Accepted Drainage Impact Assessment
under Previous Application No. A/NE-MUP/185

**Proposed Temporary Warehouse with Ancillary Facilities for a
Period of 3 Years and Associated Filling of Land in "Agriculture" and
"Residential (Group D)" Zones, Lots 107 (Part), 109 (Part), 115 (Part), 116 (Part),
117, 118, 119, 120, 121, 122, 123, 124 S.A, 124 S.B, 125, 126 (Part), 127 (Part),
128 (Part), 131, 133 (Part), 134, 135 (Part), 136, 141, 142, 143, 144 RP (Part),
148, 150, 151 and 152 in D.D. 38 and adjoining Government Land, Sha Tau Kok
(Compliance with Approval Condition (c) for Planning Application No. A/NE-MUP/185)**

Appendix I – Response to the Comments of Chief Engineer/Mainland North, Drainage Services Department (CE/MN, DSD)

Drainage Impact Assessment Report

DRAWING NUMBER
FIGURE 3.2

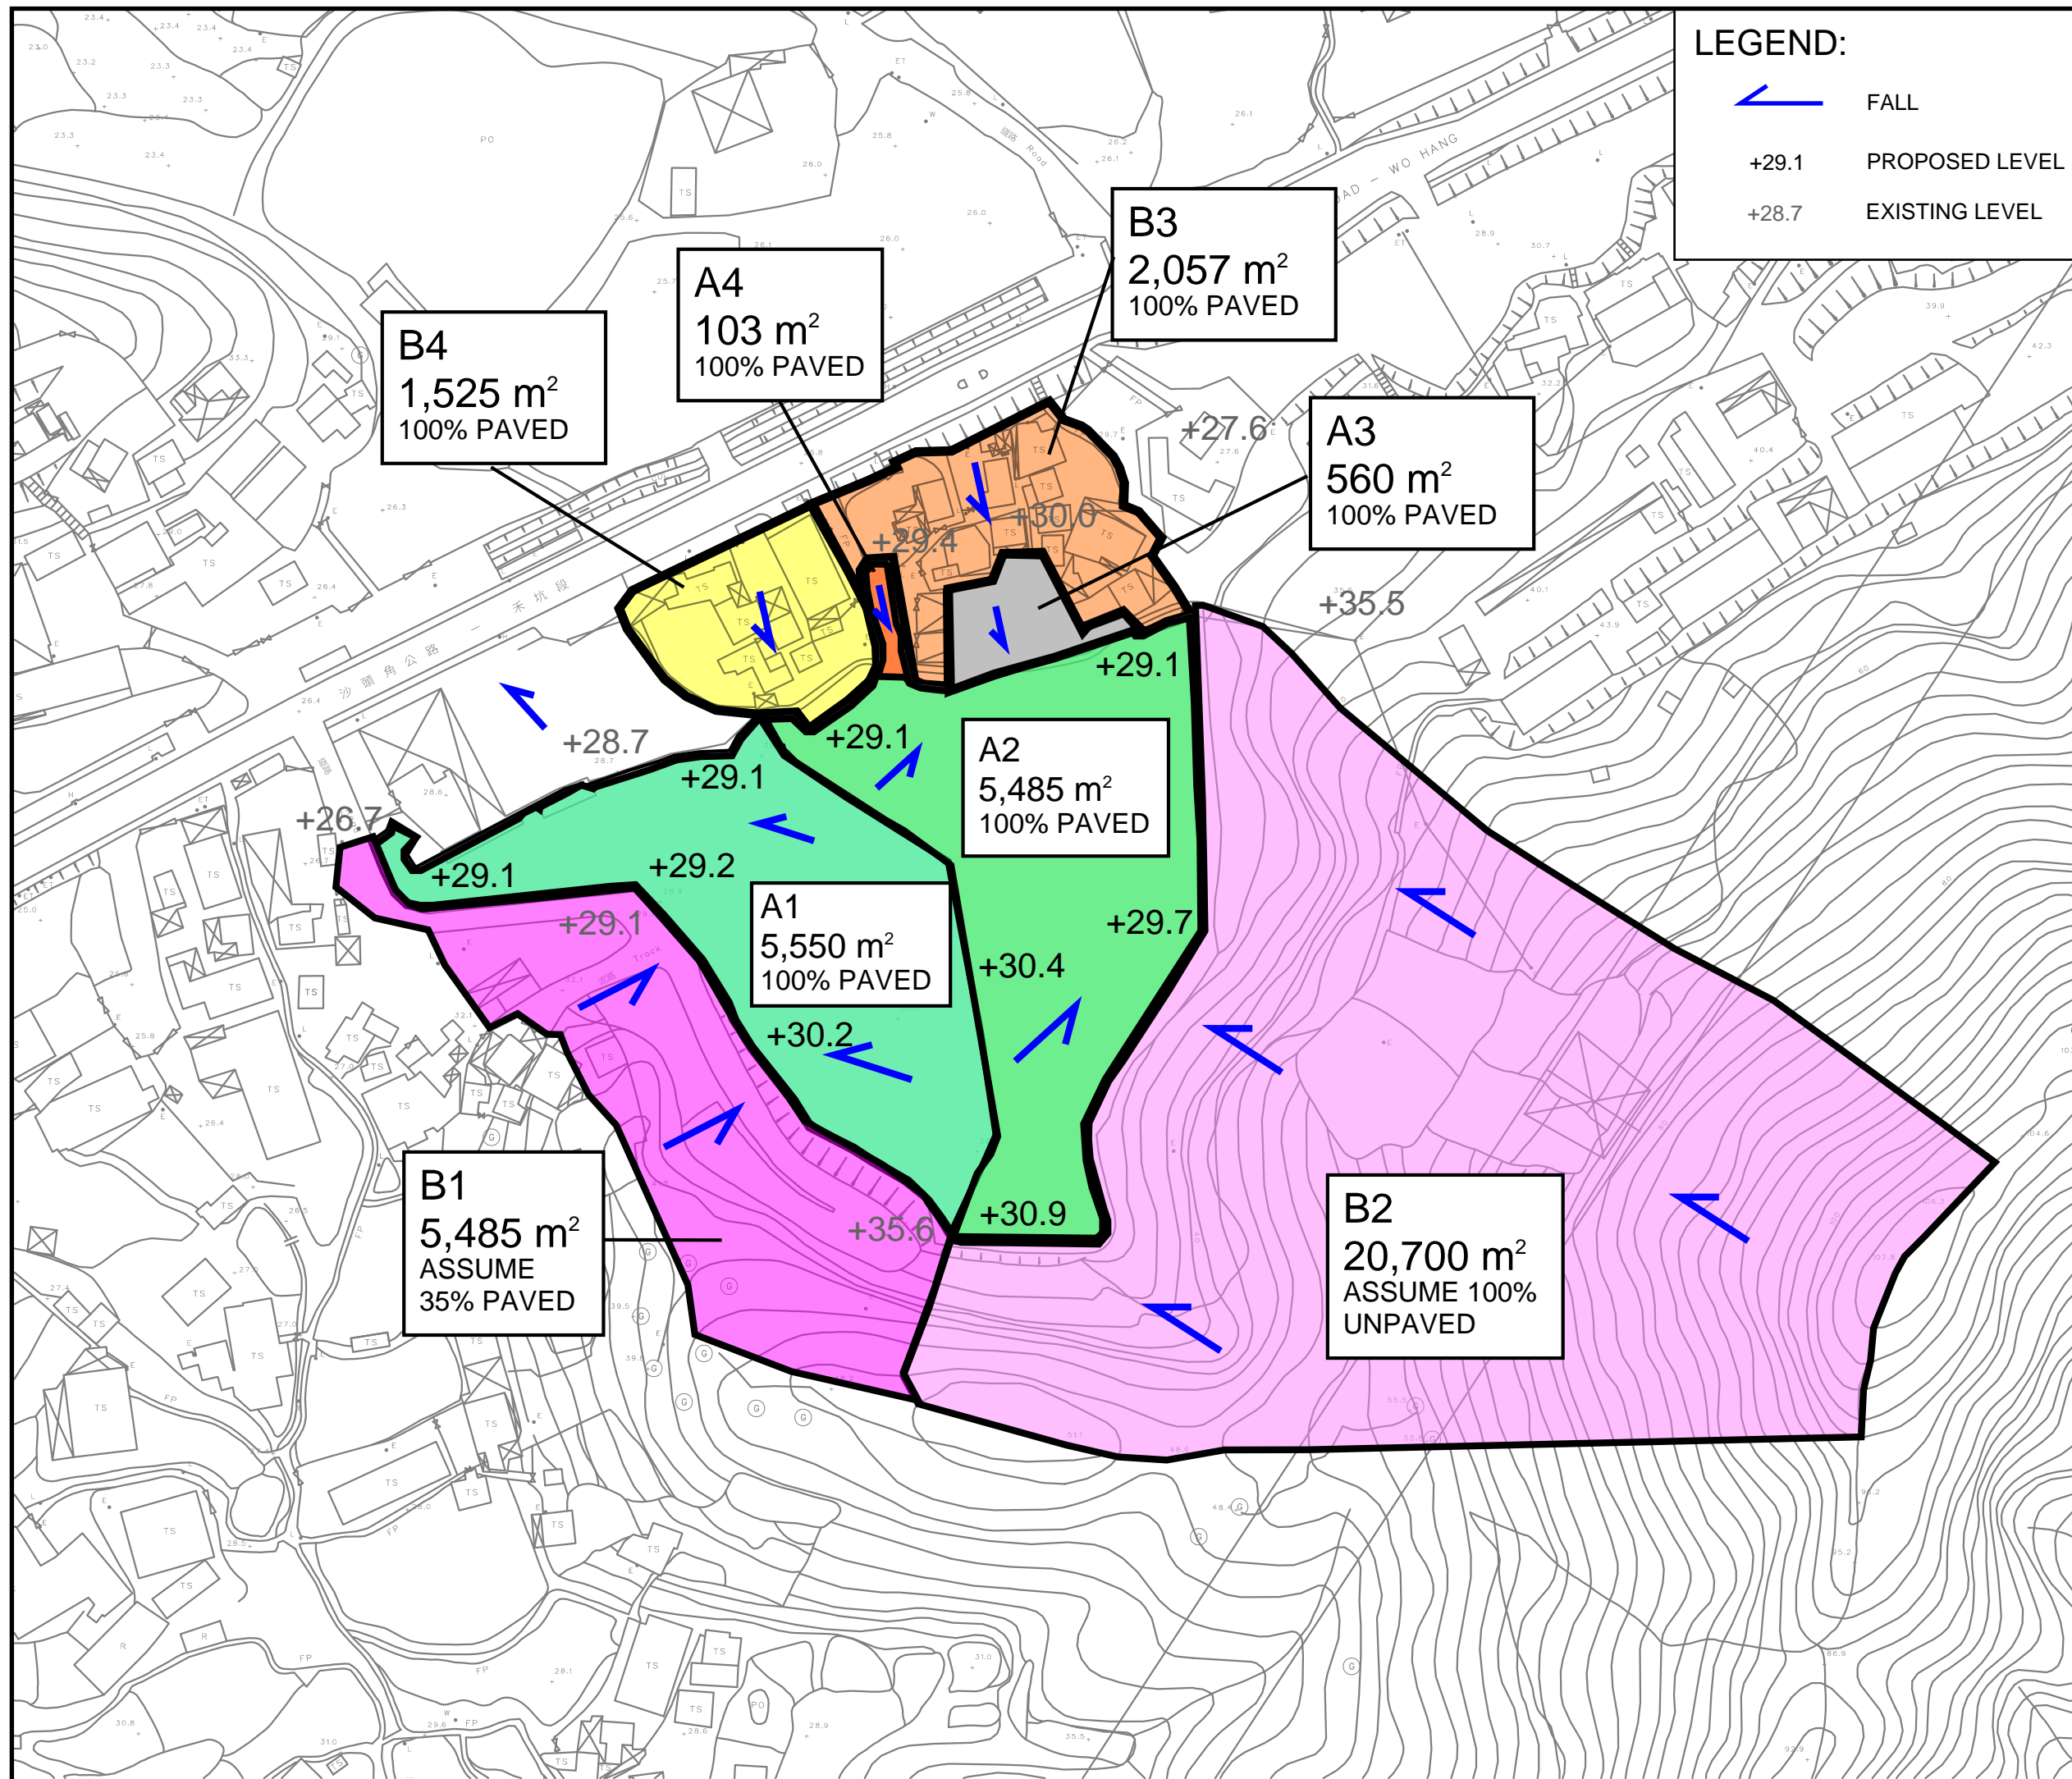
(2)	It is noted from section 1-1 in Appendix D that the formation level of some portions of the application site are higher than the adjacent existing ground level. Hence, the cover level of the proposed u-channel at those portions should be revised to match the existing ground levels so as to ensure no adverse drainage impact to lands and premises adjoining the development site.	Noted. The cover level of proposed channel should made with existing ground level on site. Please refer to updated Appendix A, Appendix D and Figure 3.2 (Appendix II).
